Manufacturing Location Change for TO-220 Clip Bond Package

Product Change Notification

Product Group: Diodes Division / July 30, 2018 / PCN-DD-015-2018 Rev. 0

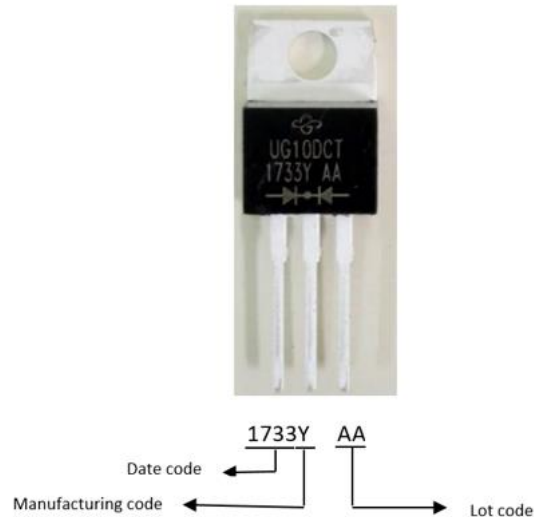
The manufacturing code "Y" will be added to the last digit of date code, lot code would be added next to date code for identification of the new manufacturing site.
